LIGHTNING F MK 3

LIST OF LETTERED ADDENDA
(EJECTION SEAT MK. 4BSC)

Addendum A

(Introduction of downward pull negative-G restraining strap)

Fig. 1 Arrangement of downward pull negative-G restraining strap in seat pan

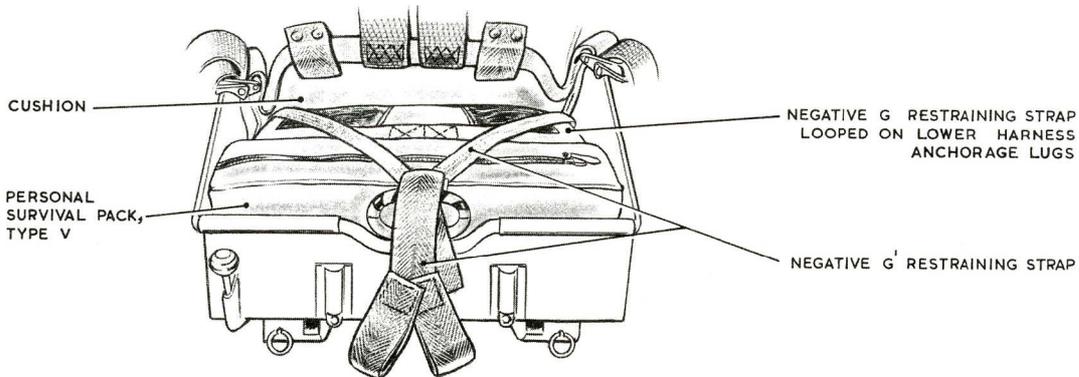
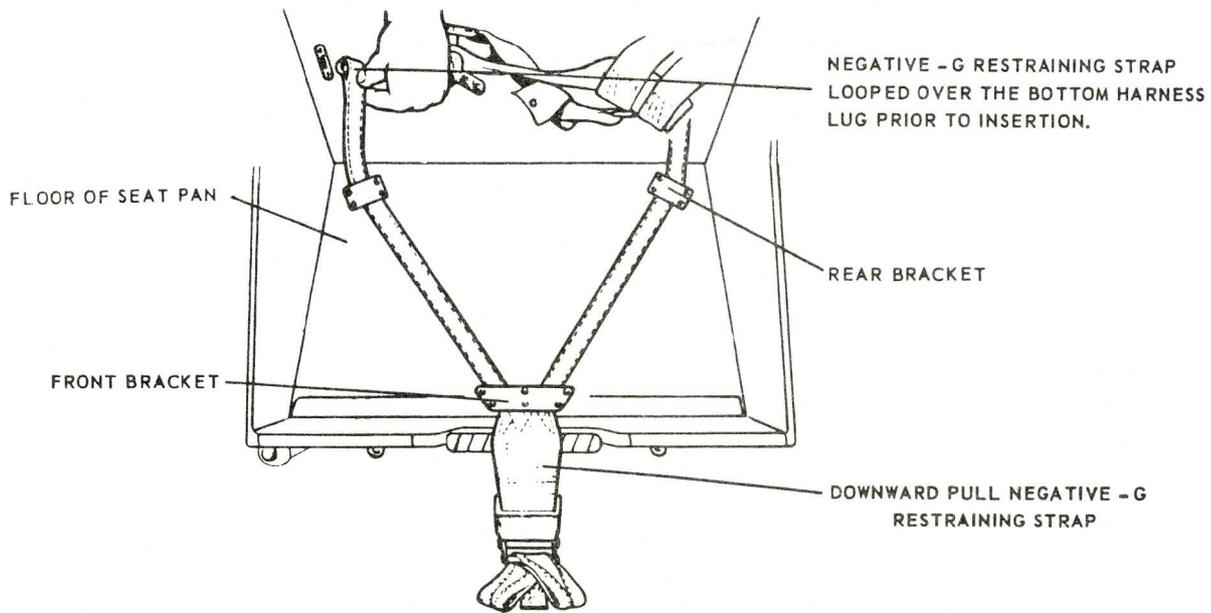
1 Modification E.S. 2690 introduces a downward pull negative-G restraint strap in lieu of the upward pull strap introduced by modification P A.69.

(5) Fig.3. Arrangement of negative-G restraining strap on P.S.P Disregard Fig. 3 in Chapter 4 and refer to Fig. 1 of this addendum.

(a) Thread the white straps through the front bracket on the floor of the seat pan from front to rear, ensuring that the yellow tab on the buckle is facing forward. The white straps are marked 'PORT' and 'STAR BOARD' and it is essential that they are so positioned to ensure correct installation.
(b) Pass the straps rearwards and thread each strap through its respective rear bracket in the floor of the seat pan.
(c) Engage the looped end of each strap over its respective bottom lock harness lug and insert the lugs into their respective bottom locks. It may be necessary to partially depress the harness release lever beneath the barostatic time release unit to

(d) Drape the blue 'Y' piece of the negative-G strap OVER THE TOP of the seat pan firing handle

Fig. 2 Arrangement of downward pull negative-G restraining strap to lap straps

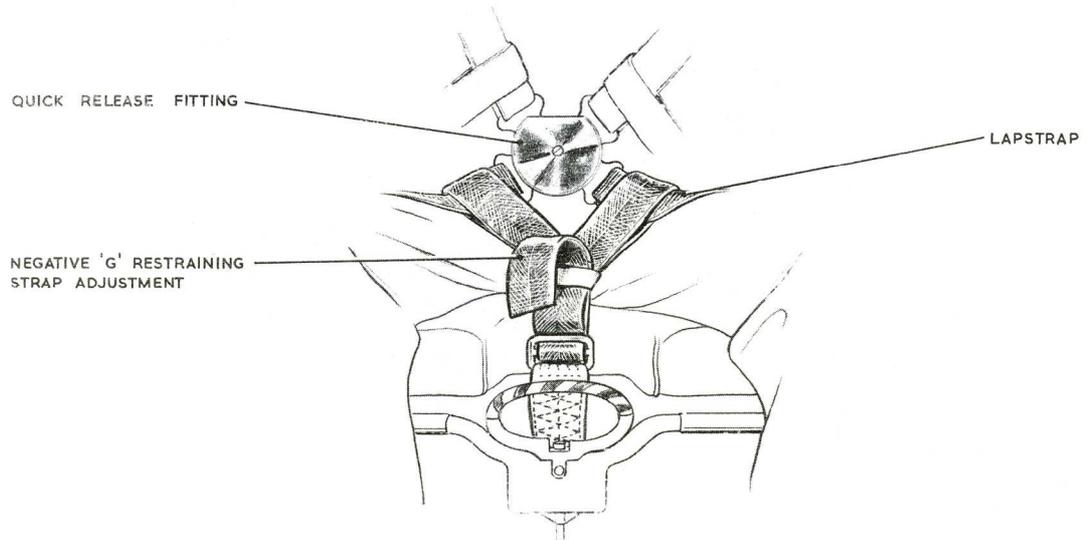
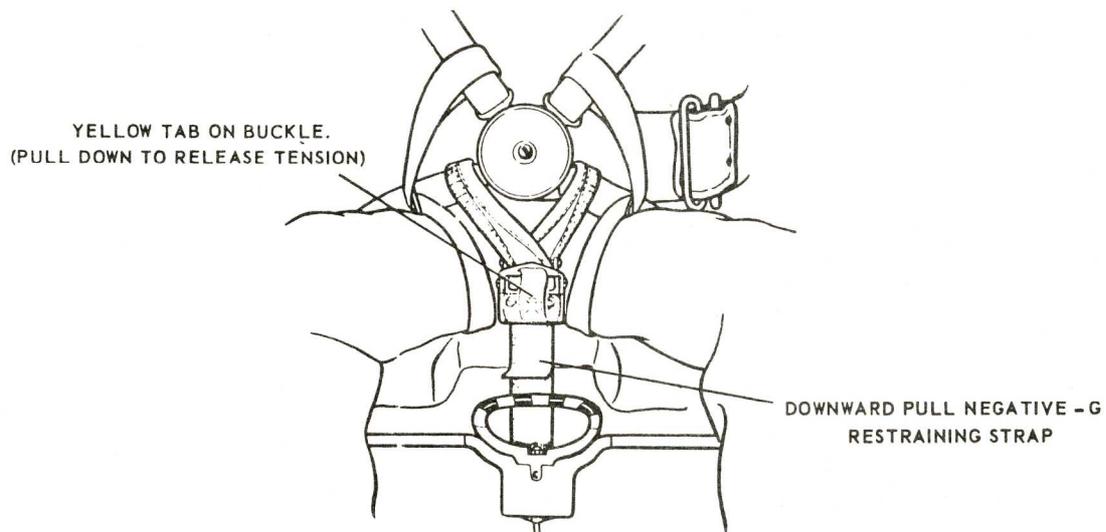
Fig.7 Arrangement of negative-G restraining strap to lap straps. Disregard Fig.7 in Chapter 4 and refer to Fig. 2 of this addendum.

Tighten the negative-G restraint strap by pulling DOWNWARDS on the free end of the blue strap until the strap is as tight as possible and ensure that the free end is then tucked down BEHIND the alternative firing handle. The strap is fitted with a snubber, which is released by pulling downwards on the yellow tab attached to the snubber lever, to loosen the strap.
